HAMS GARMENTS LTD. (EXTENSION 2)

South Vangnahati, Chapilapara, Sreepur, Gazipur
(24.194313, 90.452568)

16 February 2026

Observation-4: Mismatch found in as built drawing (WTP & Workshop Shed)

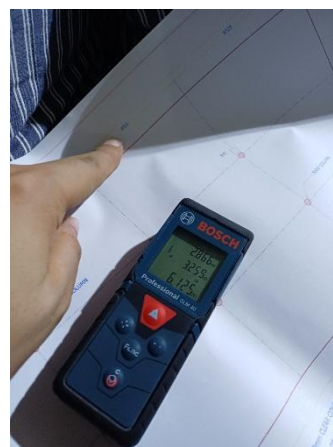
SC3 steel column web found 260 instead of 275

Description: Building engineer is required to survey the whole structure and prepare a full set of accurate as-built drawings and submit to RSC for review. Also, update the design report considering the updated as-built drawing and submit to RSC for review.
